Subject: Attention of: Planning Officer Thomas Burns - Re DA2020/1691

Regarding: Development Application DA2020/1691

4 Southern Cross Way, Allambie Heights, NSW 2100.

We are writing to object to the development application DA2020/1691 relating to the amended plans from 5th May 2021.

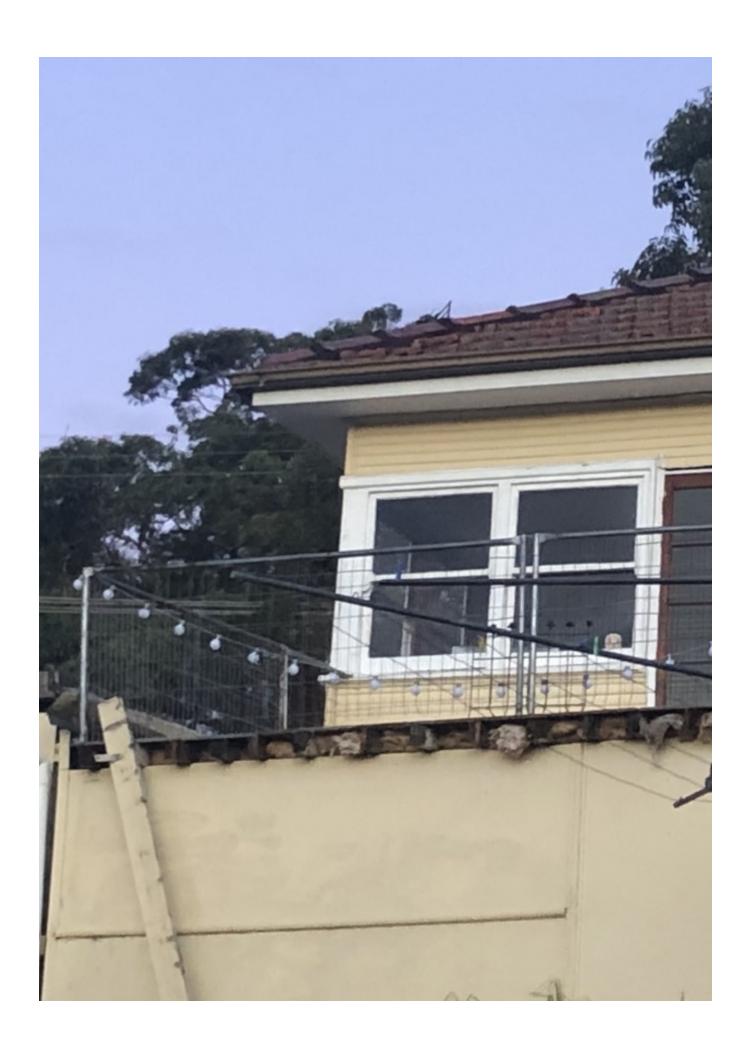
- 3) General Concerns and Misrepresentations
- a) There is still no clear drawing that shows the impact of the scale of all three buildings on our property from the easterly direction. This comes back to the impact of the 12 metre of bulk and height that will be viewed from all rear east facing surrounding properties.
- b) As mentioned previously, the existing trees to the north, south and eastern side of the property continue to be included in the drawings, even though they have now been cut back and no longer exist on the property at 4 Southern Cross.

Please remove them from the drawings as they misrepresent the existing landscaping and do not minimise the visual bulk and scale of the building to any of the surrounding properties, specifically page 21.
